TECHNICAL MEMORANDUM

Re: OU-3 BERA Work Plan Modification No. 1 – Additional Pore Water and

Sediment Sampling Locations in the Las Vegas Wash

Nevada Environmental Response Trust Site

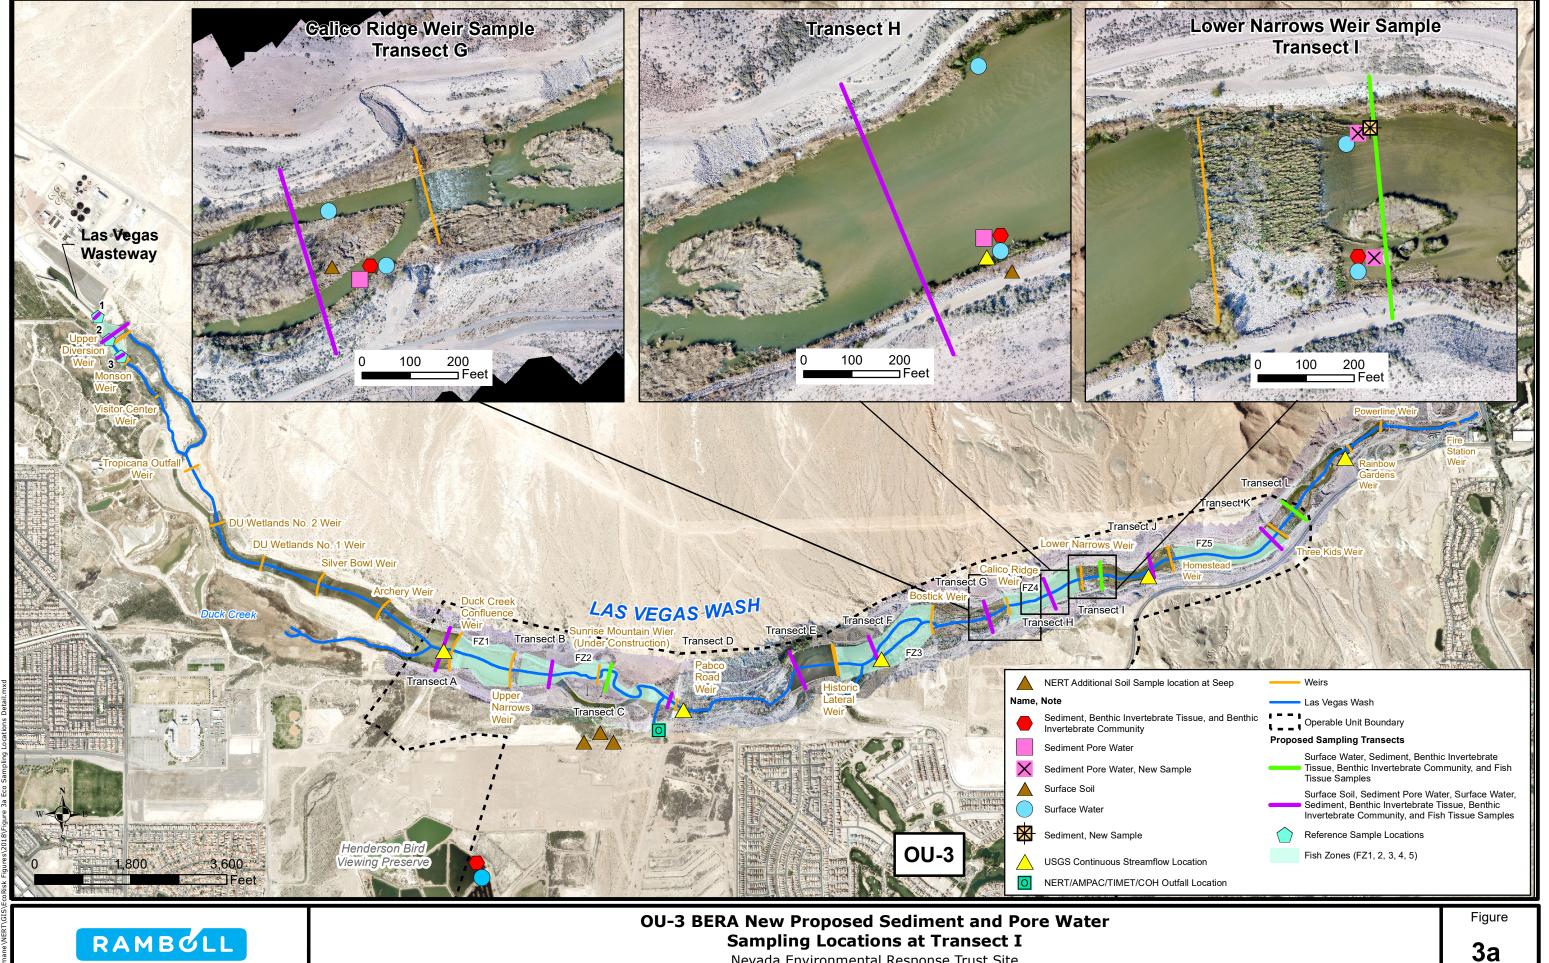
NERT3.58S1, WMW3.5S and NERT3.60S1 on the south bank near Transect L. Based on these results, additional pore water sampling is proposed along the north and south banks of the Wash at Transect I (Figure 3a), along the north bank of the Wash at Transects J and K (Figure 3b), and along the south bank of the Wash at Transect L (Figure 3b). Additional sediment sampling is proposed co-located with the pore water sample location along the north bank of the Wash at Transect I (Figure 3a). The locations of sediment samples already proposed to be collected as part of the original OU-3 BERA Work Plan (Ramboll 2019) may be shifted slightly to be co-located with other newly proposed pore water samples.

Transect	Additional Proposed Samples		Figure Number
	Pore Water	Sediment ^(a)	
Transect I	2	1	Figure 3a
Transect J	1	0	Figure 3b
Transect K	1	0	Figure 3b
Transect L	1	0	Figure 3b
